**SUBJECT: REQUEST FOR PROPOSALS FOR THE PERFORMANCE OF EXPERT PROFESSIONAL SERVICES FOR THE ADVANCEMENT OF CONCEPTUAL DESIGN WITH OPTION FOR “AS-NEEDED” TECHNICAL ADVISORY SERVICES FOR THE LINCOLN TUNNEL HELIX REPLACEMENT PROJECT– RFP NO. 58219- ADDENDUM # 2**

The Port Authority of New York and New Jersey (the Authority) hereby amends the subject Request for Proposal (RFP), dated August 21, 2019, as follows:

Figure 1 – Traffic Simulation Study Area

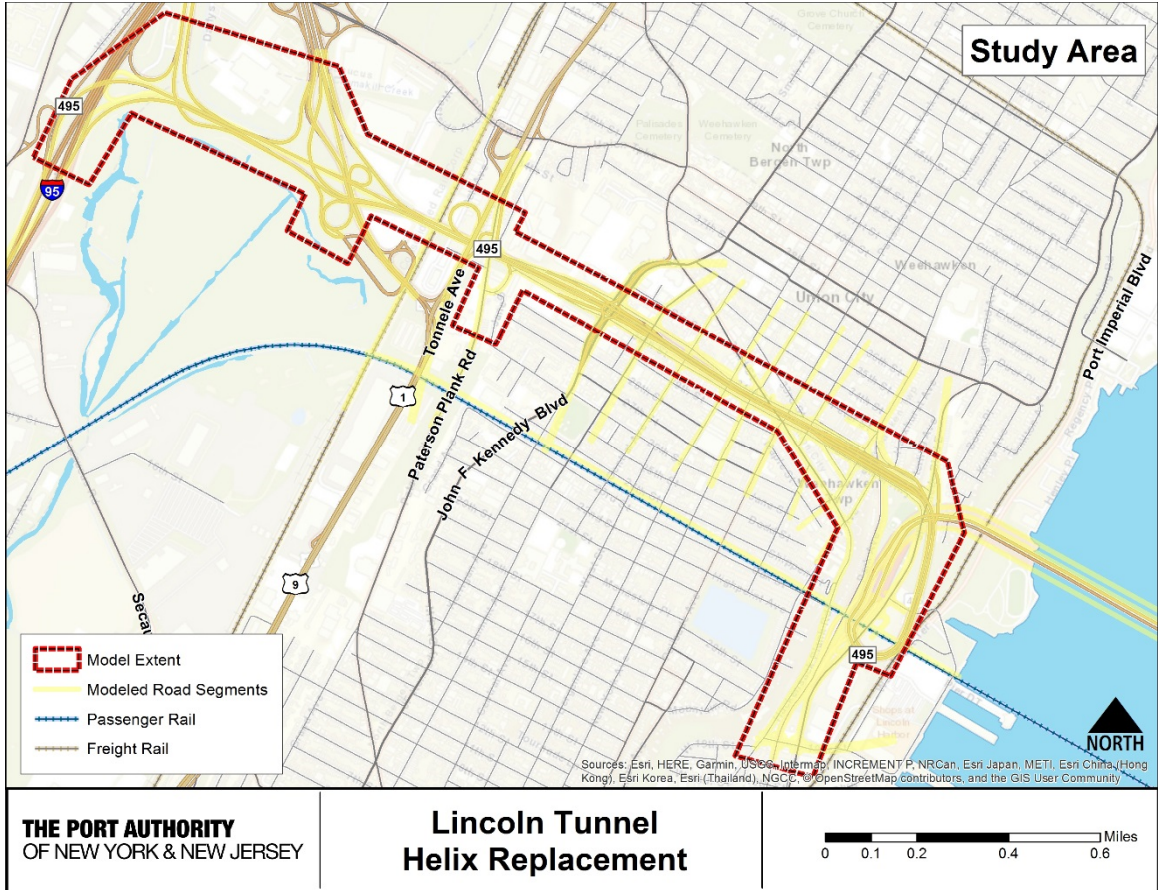
- 1) In the RFP Attachment A Scope of Work, page 21, Task D. Field Services subsection 2a **Insert:** Appendix A Traffic Model Study Area -Figure 1 Traffic Simulation Study Area and Figure 2 Traffic Simulation Model Map.

**Question 3:** Can the Authority please provide copy of the AIMSUN model to proposing entities, such that a better understanding the modeling completed to date can be understood in order to requested understand the scope of modeling work. If the model cannot be made available can a map of the roadway network included in the AIMSUN model to estimate the required modeling effort and cost?

**Answer 3:** The full AIMSUN model will not be made available until after the award of Proposal. See Appendix A Traffic Model Study Area.
